Development Control Committee B – 13 June 2023

SITE ADDRESS: U Shed Canons Road Bristol BS1 5UH

APPLICATION NO: 22/00933/F Full Planning

RECOMMENDATION: Refuse

Above: The view from Narrow Quay illustrating the architectural and visual prominence of the Cathedral in dockside views. V-shed on 1926 is on the left, with U-Shed on the right. The visual effect of the saw-tooth roof profile adds skyline interest. 39 degree field of view from Narrow Quay

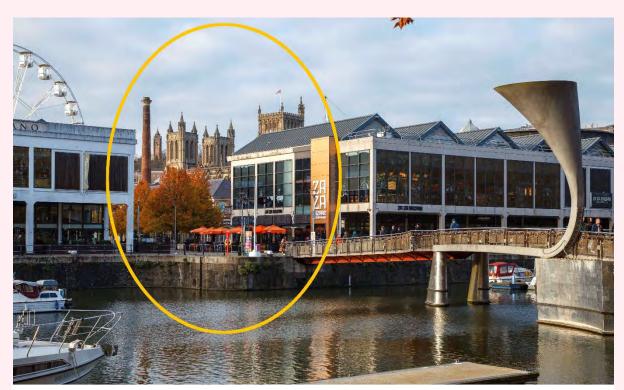
- 2.1 The legibility of the Cathedral in the docks area is important as part of its architectural and historic significance. All the land between it and the water edge was historically part of the original Abbey's demise, and the prominent position elevated above the docks emphasised the power and influence of the medieval church. The three landmark towers of the church are a visual focus for numerous views across the Docks Conservation Area and further afield. Even glimpsed views within the area are important in ensuring the building retains its architectural and topographical dominance. The Conservation Area Character appraisal states:

"Gimpsed Views (GV) - allow intriguing glances via gaps or intimate routes that permeate the local area. They make an important contribution to local character and distinctiveness"

The long, low-slung profile of the transit sheds emphasises the defining horizontals of the Listed dock walls, the surface plane of the water, and the length of St Augustine's Reach. 84 degree field of view from Narrow Quay

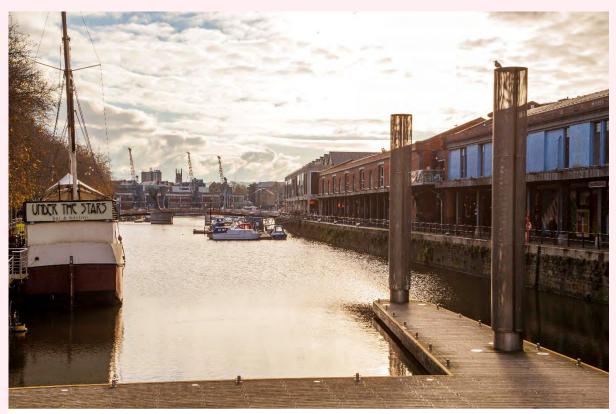
- 2.3 To the north of U-Shed are two earlier transit sheds, now forming the Watershed media centre. These are both individually Grade II listed. Both are more traditional in form, with wide pitched roofs running their length. Cranes were not integrated into the roof like the later transit sheds but were attached along the dock frontage of the building. These transit sheds did set the overall character along the west side of St Augustine's Reach (the Reach) in the following decades, with the same practical long and low-profile sheds maximised for dockside exposure, and a narrow planform suitable for quick movement of goods across the floor from quayside to road or track. The incorporation of an open arcade at ground level was also a practical solution allowing access to the ships moored alongside, whilst allowing direct cargo movements by crane at the upper level.

- 2.4 The four buildings along this side of the Reach, together with M-Shed to the south of the dock, are either designed to, or replicate, the clear practical requirements of the transit sheds as a building type and are an architectural expression of those industrial functions. As such they have high evidential value and a group, illustrating how the docks were used and operated until their commercial closure in the 1970s. this is the only part of the Docks that retains these characteristic buildings that, before WWII, were the predominate building type of the docks.

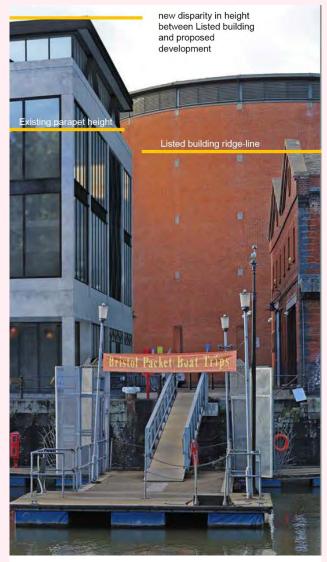
- **3.5** Proposed elevational treatments would omit the traditional red brick of the current U-Shed and focus on extensive glazing, profiled metal panels fascia strips, and screens. The top storey would be set back from the new parapet height, with the existing saw-toothed roof evoked with angles structural members within a flat façade below the projecting eaves of a flat roof.

- **3.6** The proposed proportions of the building elevation would be on a wider spaced grid than the existing U-Shed, replacing the 16 horizontal divisions with eight, and an increased height given to the infill panels within the intended expressed frame structure.

3.7 A final important change will be a reduction in height of the existing public arcade forming the public harbour walkway. A current arcade height of around 3.8m will be reduced to 3m.

Detail of viewpoint 02 showing the new disparity in scale that would occur between the existing Listed W-Shed, and proposed development.

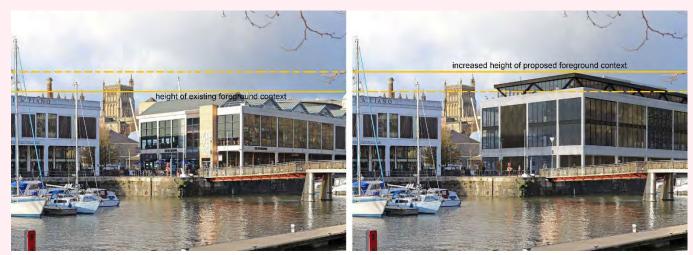
- 4.7 Viewpoint 04 looks towards the building across Anchor Square. The temporary instillation of the sky-view big wheel tends to dominate this angle. As part of this exercise, we should consider the view without that incursion, and the effect of the repeated gable roofs becomes more dominant on the skyline. Although differing from the 1920s roofs the current building replicates and reinterprets the original industrial character of repeated roofs, the expressed structural frame, projecting first floor hoists, and the use of red brick infill panels of the building it replaced.

- 4.8 The architectural impact of the corner most prominent in this view has changed from the original 1990s proposals with the replacement of the prominent first floor brick infill panel with an industrial type window with a tight grid of glazing bars dividing the glazing into panes echoing the proportions of the structural grid within which they sit. Above this a series of terracotta toned cladding panels replace the glazed gable. The colour complements, but doesn't match, the red of the brick elsewhere in this façade.

Diagram produced using the scale massing model in Vucity illustrating the impact of the loss of characteristic roof profile, increased height, and the impact on the setting of Listed assets. 39 degree field of view from the cafe deck of the Architect

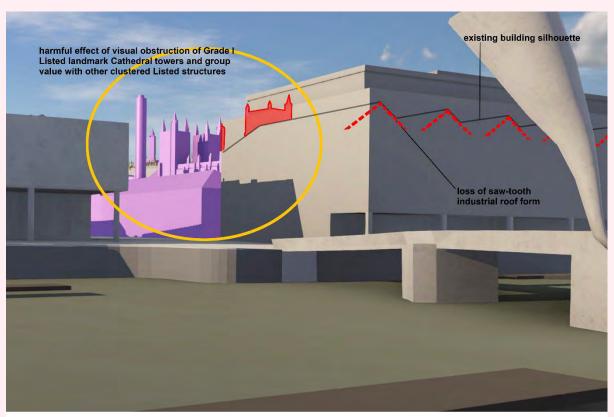
- 4.19 From a series of sequential views along Narrow Quay the impact of the low-slung horizontal emphasis of the buildings was reviewed from the north and east of the site. As with the verified

views from the south, these indicated that the scale of the building, and the loss of the saw-tooth roof of the existing U-Shed undermined the strength of character along this key frontage.

Diagram produced using the scale massing model in Vucity illustrating the impact of the loss of characteristic roof profile, increased height, and the impact on glimpsed views . 39 degree field of view from Narrow Quay

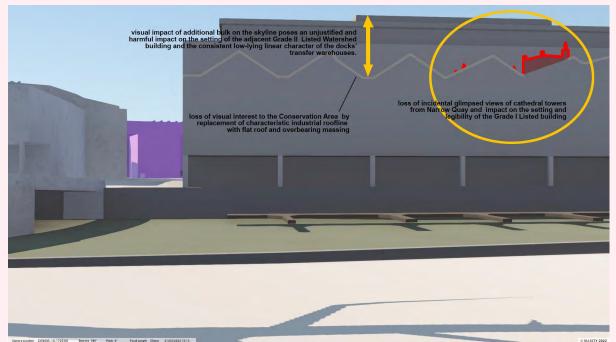
4.20 A site walk along Narrow Quay, and the sequential views, identified several locations where glimpsed views of the Cathedral tower and pinnacles helped orientate the visitor within the topography of the historic city. These glimpsed skyline views over the top of the roofline of U-Shed would be lost, impacting the Cathedral setting. The removal of the characteristic saw-tooth roof in views directly across the Reach resulted in a marked loss of distinctive character, where open sky

seen through valleys was replaced with solid built form.
